Roland Memorial Hall Addition & Renovation  
**Addendum No. 2**

**MECHANICAL  
ADDENDUM  
#1**

Project #: 03-038  
Project: Roland Memorial Hall

**ELECTRICAL  
ADDENDUM  
#01**Project #: 03-038  
Project: Roland Memorial Hall  
Addition

1 WEeping TILE SUMP PIT  
MR-1 SCALE: N.T.S.

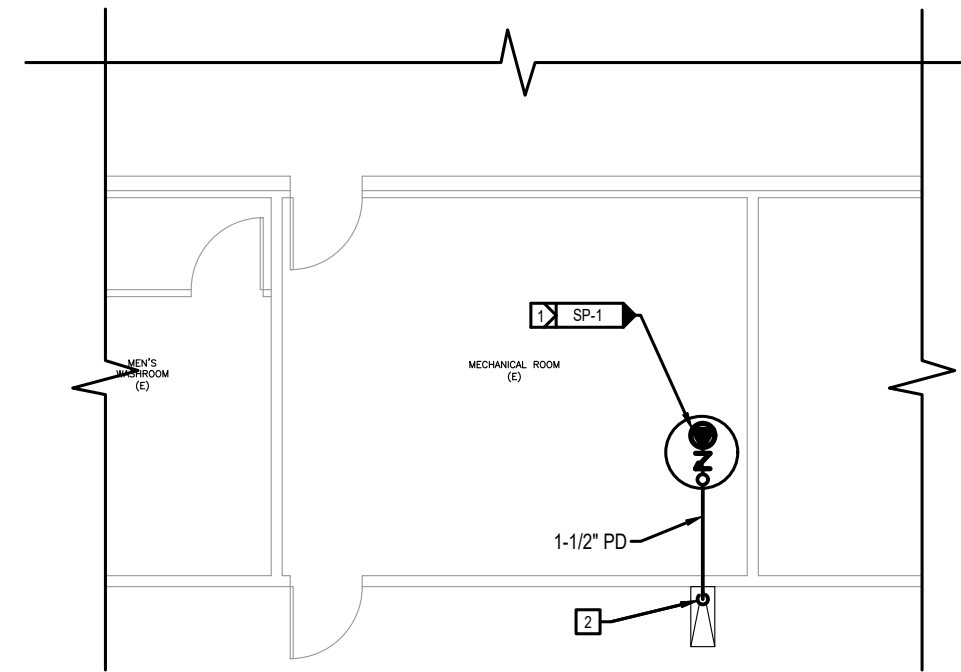
**ITEM NO. 1.: Sump Pump Addition**  
**REFERENCE: MR-1 dated 2026-04-21**

- .1 Supply and install sump pump in pit. Provide with check valve on pump discharge.
- .2 Provide with control panel c/w audible/visual high level alarm.
- .3 Mechanical contractor to provide scanning/scoping of existing sanitary line in area to determine exact as-built condition
  - .1 Modify final placement of pit to accommodate as-built conditions and maintain structural clearances (see structural).
- .4 Provide downturn elbow on sump pump discharge.
  - .1 Discharge to concrete splash pad at grade (pad by G/C.). Insulate pumped discharge piping min. 10'-0" back from wall penetration. Site coordinate final discharge location with owner's rep and G.C.. Extend piping to final termination point as required.

- 1 SUPPLY AND INSTALL SUMP PUMP IN WEEPING TILE SUMP PIT (PIT BY G.C.). PROVIDE WITH CHECK VALVE ON PUMP DISCHARGE. PROVIDE WITH CONTROL PANEL C/W AUDIBLE/VISUAL HIGH LEVEL ALARM. SITE VERIFY FINAL PIT PLACEMENT WITH EXISTING INFRASTRUCTURE AND STRUCTURAL REQUIREMENTS. MECHANICAL CONTRACTOR TO PROVIDE SCANNING/SCOPING OF EXISTING SANITARY LINE TO DETERMINE EXACT AS-BUILT CONDITION. MODIFY FINAL PLACEMENT OF PIT TO ACCOMMODATE AS-BUILT CONDITIONS AND MAINTAIN STRUCTURAL CLEARANCES (SEE STRUCTURAL). REFER TO DETAIL.
- 2 PROVIDE DOWNTURN ELBOW ON SUMP PUMP DISCHARGE. TO DISCHARGE TO CONCRETE SPLASH PAD AT GRADE (PAD BY G.C.). INSULATE PUMPED DISCHARGE PIPING MIN. 10'-0" BACK FROM WALL PENETRATION. SITE COORDINATE FINAL DISCHARGE LOCATION WITH OWNER'S REP AND G.C.. EXTEND PIPING TO FINAL TERMINATION POINT AS REQUIRED.
